AGENDA - TROY PLANNING COMMISSION MEETING
WEDNESDAY, MAY 10, 2023, 3:30 P.M.
CITY HALL, COUNCIL CHAMBERS

MEMORANDUM

SUBJECT: Certificate of Appropriateness – 9 West Main Street.

SUBJECT: Certificate of Appropriateness – 110 – 112 E. Main Street

Project Name: THE MAYFLOWER

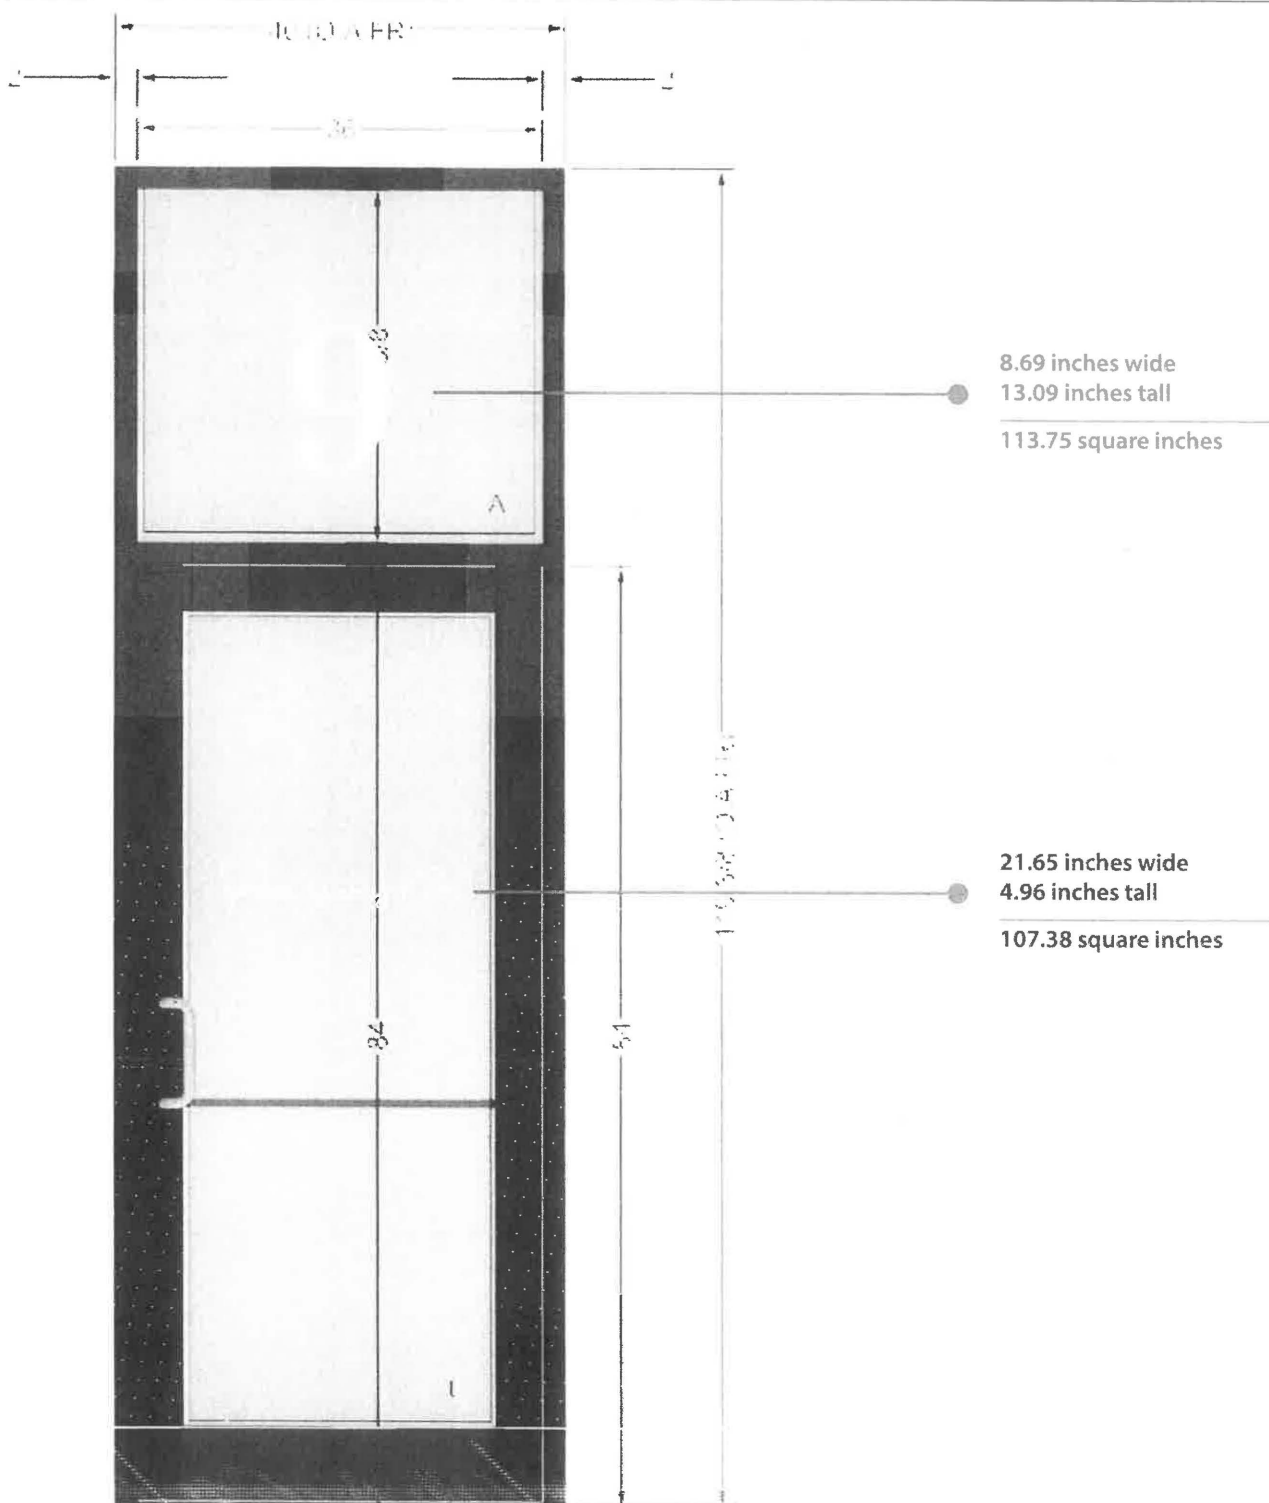
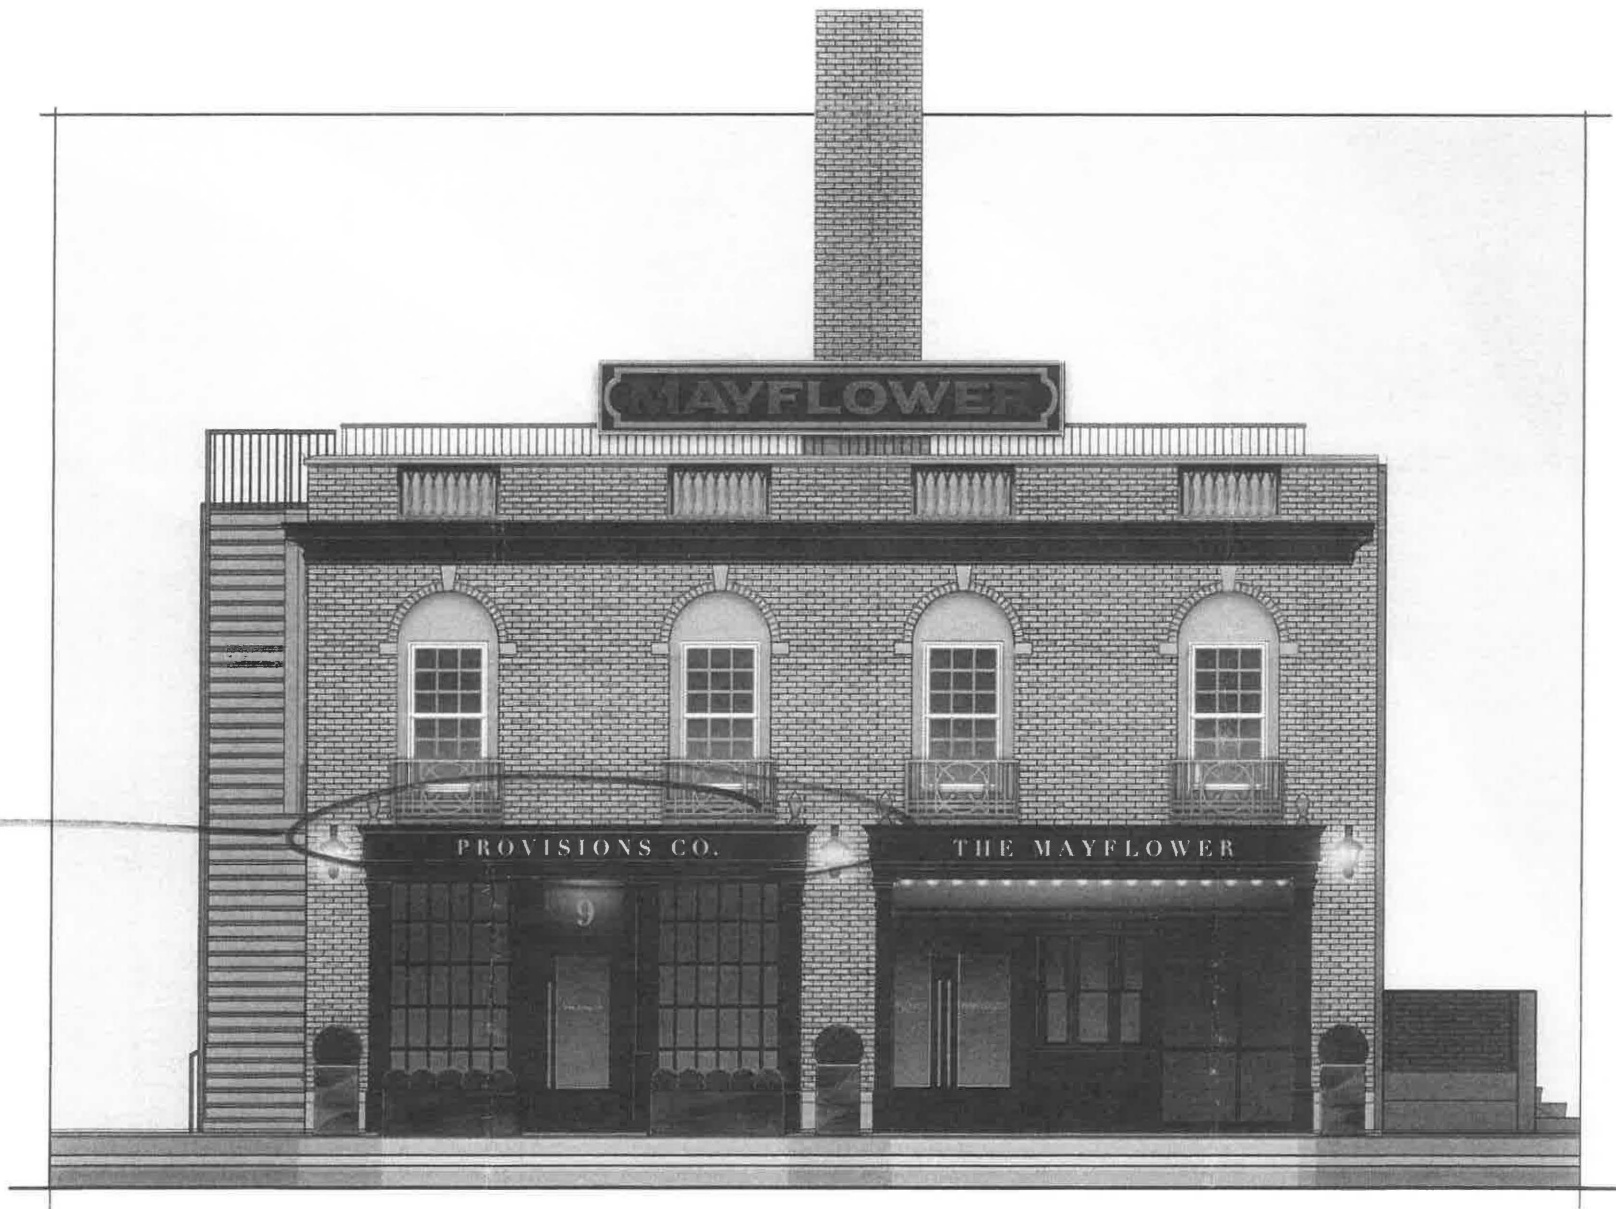
The applicant is proposing installation of new signage above the entry doorway, the transom window and entry door of the western entryway of the south façade of the building. This entryway faces West Main Street. The lettering above the doorway will read “Provisions Co.” measuring 115 inches by 6.75 inches and will be stand-off acrylic bronze. The transom window signage will be the number “9”, measuring 8.7 inches by 13 inches and will be made of white vinyl. The lettering on the entry door will read “Provisions Co.” measuring 21.6 inches by 4.9 inches and will also be white vinyl. The final appearance is indicated in the graphics.

Design Manual. The Design Manual section 5.4 states “wall signs should be three dimensional, with letters carved by a router, or; letters should be individually pin-mounted or incorporated into a sign panel. The proposed signage meets section 5.4 of the Design Manual.

Staff recommends approval of the proposed signage based on the following:

- The signage complies with section 5.4 of the Design Manual.

PINNACLE CLAD
DOUBLE HUNG
QUOTE: 2209799 LINE: 100
ROOM 1D: DOUBLE HUNG QTY: 10

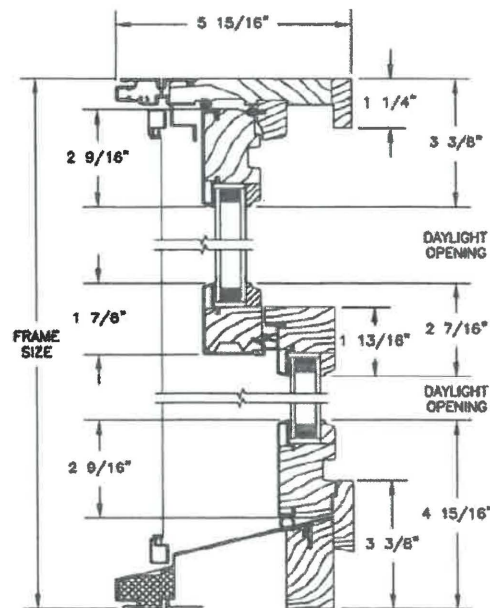
The applicant is requesting approval from the Planning Commission to review the replacement of twenty (20) second floor windows with the same manufacturing and design as the previously approved third floor windows. The proposed window design is the Mueller Roofing Distributors “Pinnacle Clad Sandstone 7/8” Standard WDL with Inner Bar”. Please see below design graphics:

While this does not follow the Secretary of Interior Guidelines, Planning Commission previously approved matching windows on the third-floor and the first-floor of this building. The applicant wishes to balance the second-floor windows with the previously approved third and first floor windows. The windows will maintain the double hung functionality of the original windows. The muntins and inner bar will be on the exterior of the window and will maintain those characteristics of the original windows.

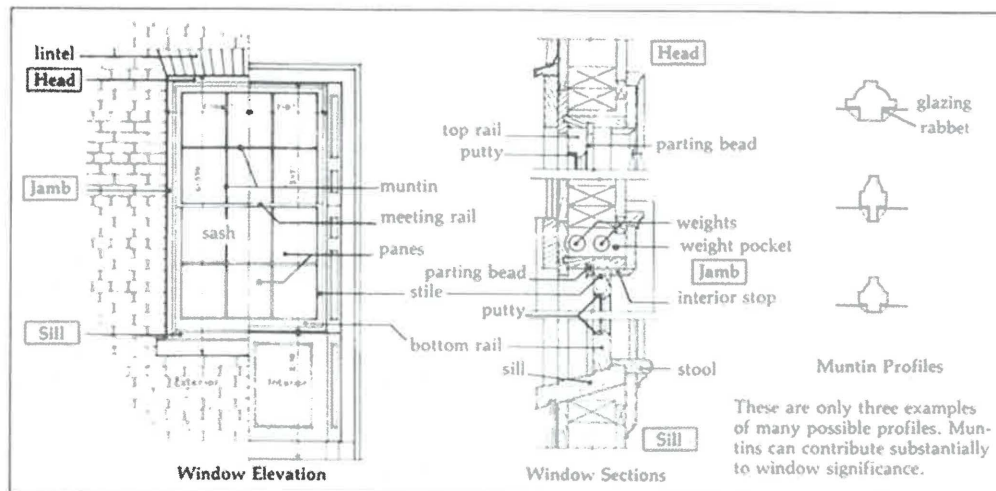
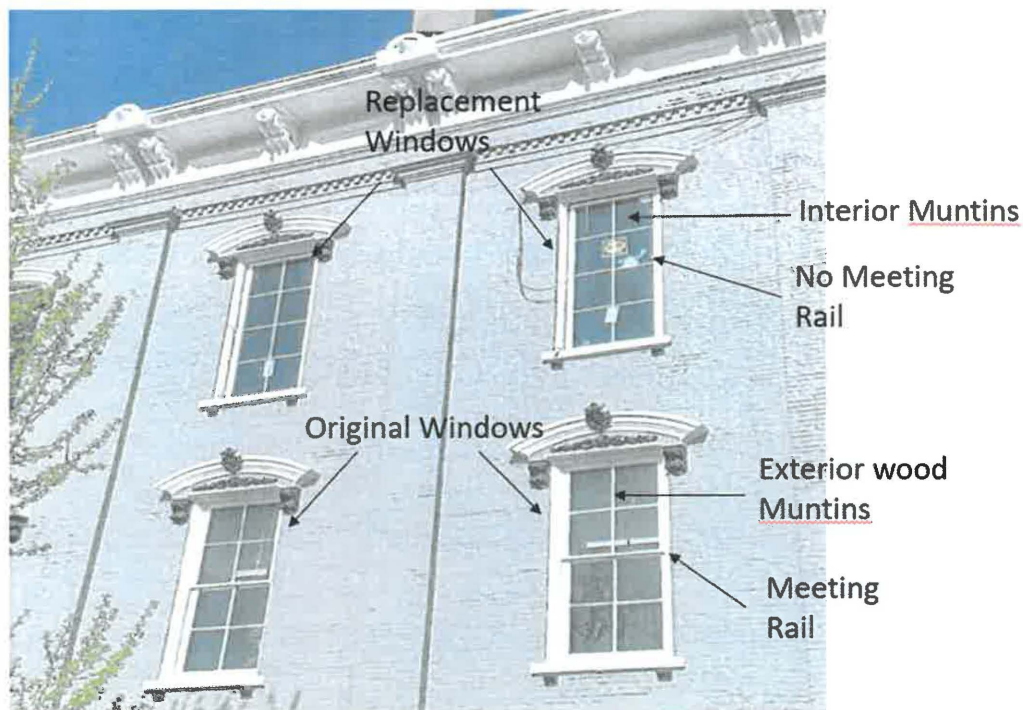
The applicant is requesting to use Pella 250 Series, Direct Set, Fixed Frame windows as the replacement windows. The proposed windows are single pane that do not have a meeting rail. The muntins are also located inside of the window pane. The color will be white. Please see below diagram; Identifying window terminology from the Secretary of the Interior Preservation Brief #9:

Referencing Historic Preservation Brief No.9 from the US Secretary of the Interior's Standards for Historic Properties, The Repair of Historic Wooden Windows; "Windows are an important aspect to the architectural design and character of any building. From their craftsmanship, design and other qualities make them worthy of preservation."

Repairing or rehabbing rather than replacement is the preferred method for most window treatments. Most millwork firms can duplicate parts which can be incorporated into the existing window. Replacement of certain portions, patching, or splicing maybe more appropriate. With replacement, the contribution of the window should be taken into consideration. The pattern of the openings and their size; proportions of the frame and sash; configuration of the window panes; muntin profile and size; types of wood or material; paint color; characteristics of the glazing, and any other associated details.

The Secretary of the Interior's Standards for the Treatment of Historic Properties is very specific in not recommending changes to the appearance of windows that contribute to the historic character of a historic building. This would include replacing materials, finishes, or colors which would noticeably change the sash, depth of reveal and muntin configuration; the reflectivity and color of the glazing or appearance of the frame is not recommended.

The City of Troy Design Manual States: "Replacement windows should match the appearance of the historic originals in number of panes, dimensions of sash members, and profile of sash members and muntins. Windows should simulate the operating characteristics of the originals.." Please see below visual differences in the replacement windows:

RECOMMENDATION:

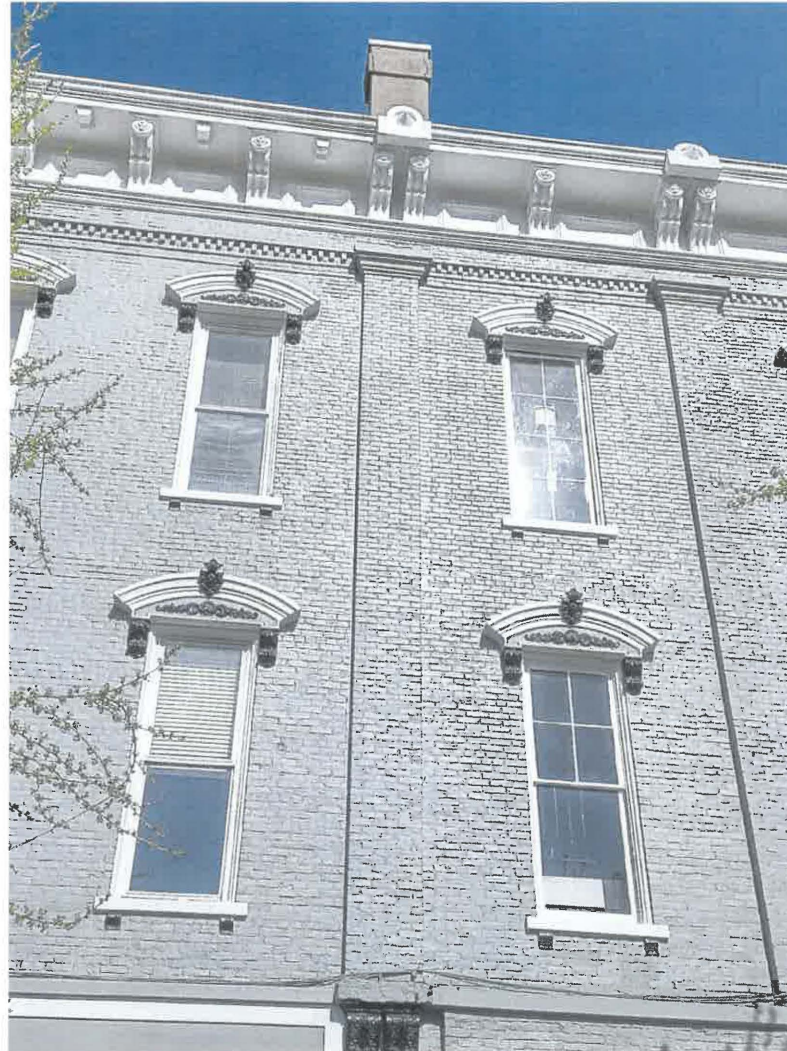
These are the original windows.

These are the new windows. We worked very hard to try to replicate the look of the old windows.
